Access Compliance Report

Public Rights-of-Way

(Curb Ramps)

Intersection ID: 10039788	Main Street: TOLLESON_AV	Cross Street: N/A	Location:	N
ADA ID: FC9815AD9AC8	Ramp Type: PerpDiag	Initial Pass/Fail: Fail	Overall Compliance: No	Severity Score: 12.5
Codes/Mitigation Info/Possible Solution		Field Measurements/Component Compliance

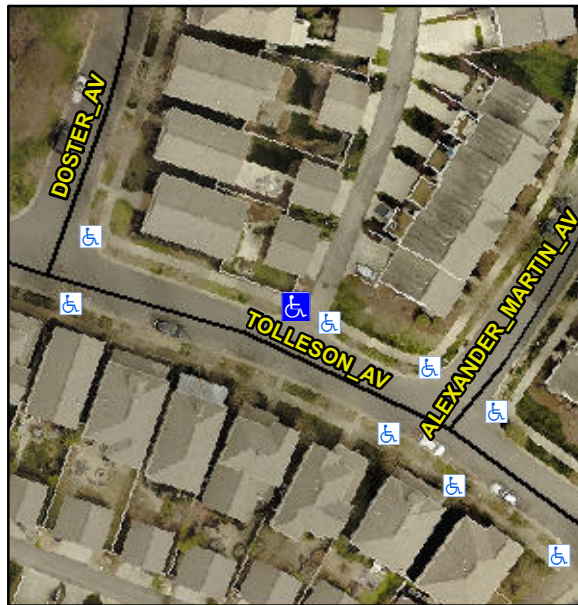
Not Found, R304.2.2

Compliance	Description	Data	Compliance	Description	Data
N/A	Ramp Length (in)	76.0	No	Ramp Slope (%)	10.9
Yes	Ramp Width (in)	48.0	Yes	Ramp XSlope (%)	0.6
N/A	Flare Type LT	N/A	N/A	Flare Type RT	N/A
N/A	Flare Slope LT (%)	N/A	N/A	Flare Slope RT (%)	N/A
N/A	Flare Traversable LT?	N/A	N/A	Flare Traversable RT?	N/A
N/A	Landing Length (in)	N/A	N/A	DWS Provided?	N/A
N/A	Landing Width (in)	N/A	N/A	DWS Contrast?	N/A
N/A	Landing Slope (%)	N/A	N/A	DWS Length (in)	N/A
N/A	Landing X Slope (%)	N/A	N/A	DWS Full Width?	N/A
N/A	Landing Curb? (Y/N)	N/A	N/A	DWS Offset (in)	N/A
N/A	Shared Landing?	N/A			
N/A	Gutter Ponding?	Yes	N/A	Gutter Slope (%)	N/A
N/A	Gutter Lip Ht (in)	N/A	N/A	Gutter X Slope (%)	N/A
N/A	Painted X Walk1?	No	N/A	Painted X Walk2?	No
	X Walk 1 Direction	To SW		X Walk 2 Direction	To SE
N/A	X Walk 1 Width (in)	N/A	N/A	X Walk 2 Width (in)	N/A
	X Walk 1 Slope (%)	3.5		X Walk 2 Slope (%)	1.8
	X Walk 1 X Slope (%)	0.9		X Walk 2 X Slope (%)	2.8

Remove & Replace Curb Ramp With Two New Directional Ramps or Equivalent.
